SERVICE INSTRUCTION

RUNNING MODIFICATIONS ON

ROTAX® ENGINE TYPE 912 AND 914 (SERIES)

SI-25-1997 R9

fig. 23

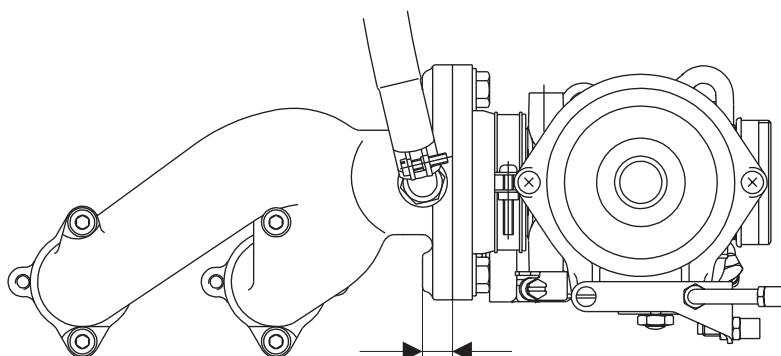
3.19) Introduction of a new flexible fuel line assy. part no. 874910 for ROTAX® 912 Series

- Install the flexible fuel line (1) with the double ring hose nipple (13) and sealing ring (10) on the clamp block (11). Tightening torque of banjo screw (14) 10 Nm (90 in. lb.) (see fig. 23).
